Deepesh Kholwadwala, Dreamcatcher ABQ North, LLC: deepesh@suncapitalhoteis.com Fairfield Suites: 4875 Pan American Frwy NE

Re: Drainage Control Ordinance (14-5-2-1) and NPDES CGP Violations for Cement Pollution and Erosion and Sediment Control- Fairfield Suites

Re: Drainage Control Ordinance (14-5-2-1) and NPDES CGP Violations for Erosion and Sediment Control- Fairfield Suites

Cement pollution.

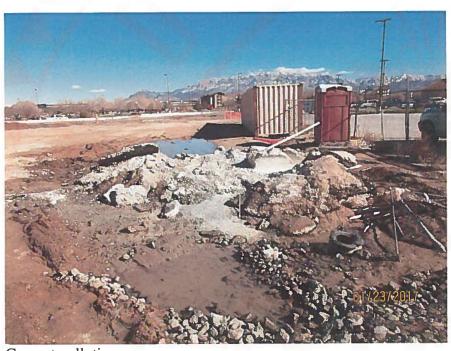
1. Numerous instances of cement pollution were observed on the site and an acceptable concrete/mortar/stucco receptacle was not on-site.

- 1. Remove the cement pollution and provide an acceptable concrete/mortar/stucco wash-out receptacle.
 - 2. Provide a sediment BMP(s) to prevent sediment from migrating offsite.

Cement pollution.

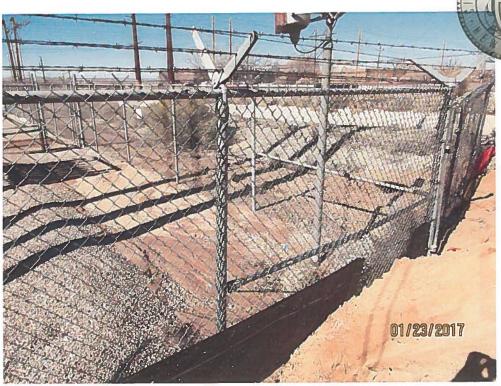
In addition, the sediment BMP (silt fence) had a gap along the southern boundary and sediment has entered the site to the south.

Drainage leaving site.

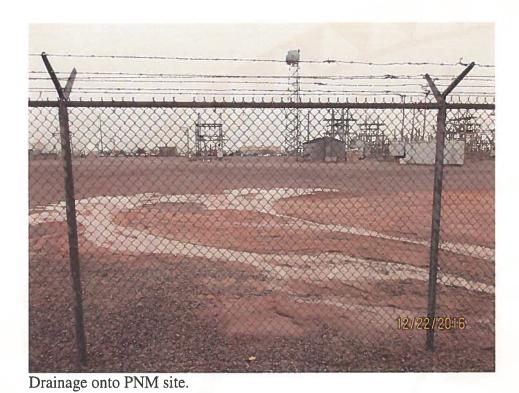
- 1. Drainage was observed leaving your site and entering the PNM substation. The photos were taken at 12:00 PM and it was still raining.
- 2. Numerous instances of cement pollution were observed and an acceptable concrete wash-out was not onsite.

- 1. Provide a temporary drainage solution that prevents drainage from entering the PNM substation.
- 2. Remove the cement pollution and provide an acceptable concrete/mortar/stucco wash-out receptacle.
- Albuquerque
